STAFF REPORT

SUBJECT: H-2021-0019

East Idaho Credit Union (EICU) Ten

Mile Branch - CUP

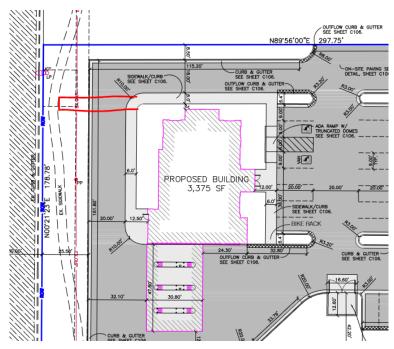
Pedestrian Walkways: No pedestrian walkway is depicted on the site plan from the arterial/perimeter sidewalk along N. Ten Mile Rd. to the main building entrance as required by UDC 11-3A-19B.4a. Therefore, the Applicant should revise the site plan to depict this required sidewalk. Specifically, Staff recommends this sidewalk connection be made near the northwest corner of the site to add the sidewalk connection to the proposed sidewalk on the north side of the building. See snip below:

Consistent with UDC 11-3A-19B.4b, the pedestrian facility should be distinguished from the vehicular driving surface through the use of pavers, colored or scored concrete, or bricks where this pedestrian connection traverses the drive-through lane.

- 2. The site plan submitted with the future Certificate of Zoning Compliance application shall be revised as follows:
 - a. Depict the required pedestrian connection from the arterial sidewalk to the main building entrance near the northwest corner of the property as depicted in Section V above, per UDC 11-3A-19B.4a— the pedestrian facility should be distinguished from the vehicular driving surface through the use of pavers, colored or scored concrete, or bricks where this pedestrian connection traverses the drive-through lane.

A. Site Plan (signed: 4/18/2022)

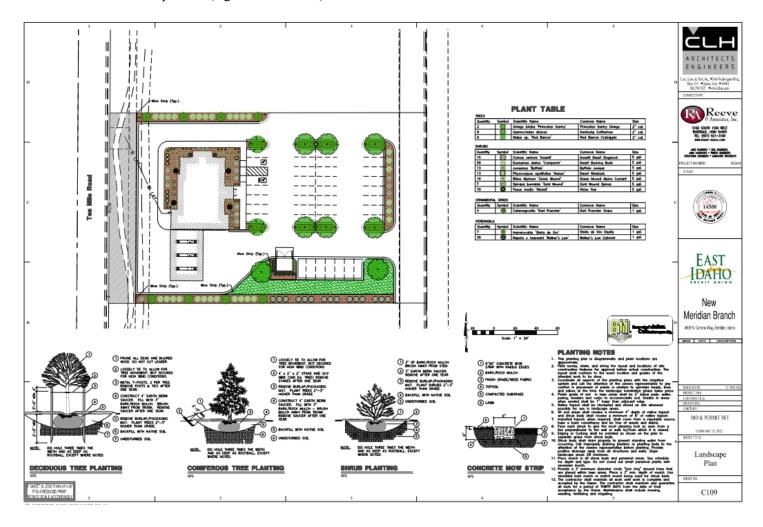
The proposed drive-through has a one-way drive aisle that circles the proposed building and leads to four (4) covered drive-through lanes for drive-up services for the bank. Therefore, the stacking lane is approximately 185 feet in length from the start of the aisle to the drive-up facilities. Due to the site design and length of available stacking Staff believes the stacking lane has sufficient capacity to serve the use without obstructing driveways and drive aisles by patrons. The Applicant should ensure there is adequate signage to direct patrons through the one-way stacking lane.

The stacking lane is approximately 185 feet in length so an escape lane is required and proposed. According to the submitted plans, a minimum 12-foot wide escape lane is proposed outside of the drive-through lane sphere of influence. Staff finds the submitted plans depict compliance with this standard.

- b. Include exhibits and locations of signage for the one-way drive through lane along the north and west boundaries.
- 3. The landscape plan submitted with the future Certificate of Zoning Compliance application shall be revised as follows:

B. Landscape Plan (signed: 4/18/2022)

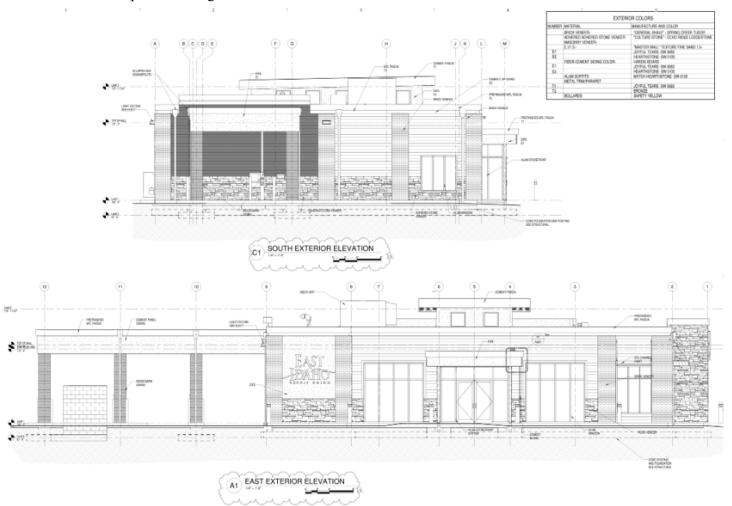
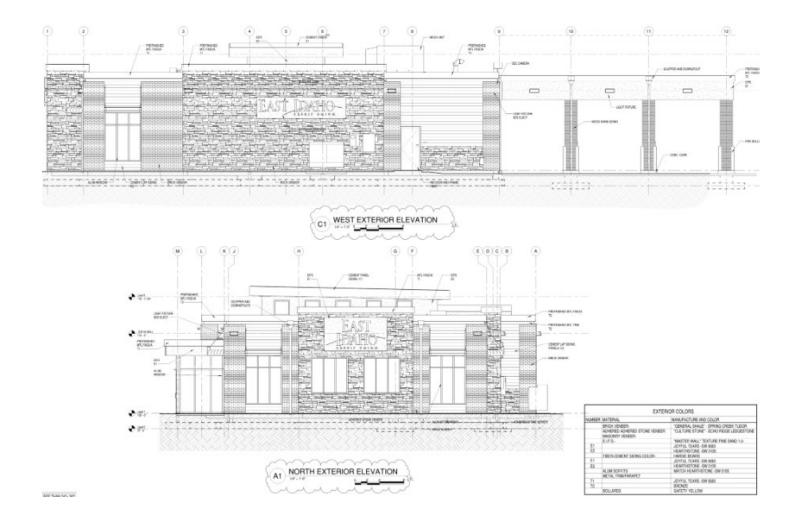
In addition, a minimum 5-foot wide landscape buffer is required to be provided along the perimeter of the parking or other vehicular use areas as set forth in UDC 11-3B-8C.1. The submitted landscape plan shows the required perimeter buffers along the north, east, and south boundaries. However, it is unclear what the reddish/brown hatched design is depicting on the submitted landscape plan for the planting areas. With the CZC submittal, the landscape plan will be reviewed to ensure compliance with the landscape material standards outlined in UDC 11-3B-5.

- a. Depict the required pedestrian connection as noted above in Section VIII.A.2a.
 - b. Ensure compliance with UDC 11-3B-5 for all landscaped areas and comply with the parking lot landscaping standards in accord with UDC 11-3B-8C.
